# TECHNICAL BULLETIN

**[Issue No.]** FA-A-0016-C

**[Title]** Additional description of serial number on the front face of the module and the package label

**[Relevant Models]** MELSEC-Q series, MELSEC-QS series

(a) Module shape 1

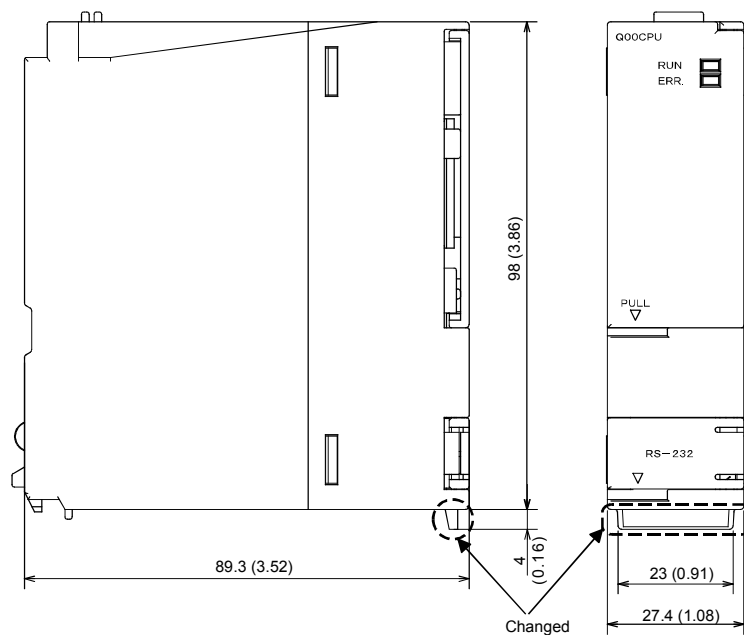
- (1) The serial number printed on the side face (rating plate) of the module will be also shown on the front face of the module. This permits identifying the serial number without dismantling the module from base unit.

- (2) Due to this improvement, module shapes will be changed as shown below.
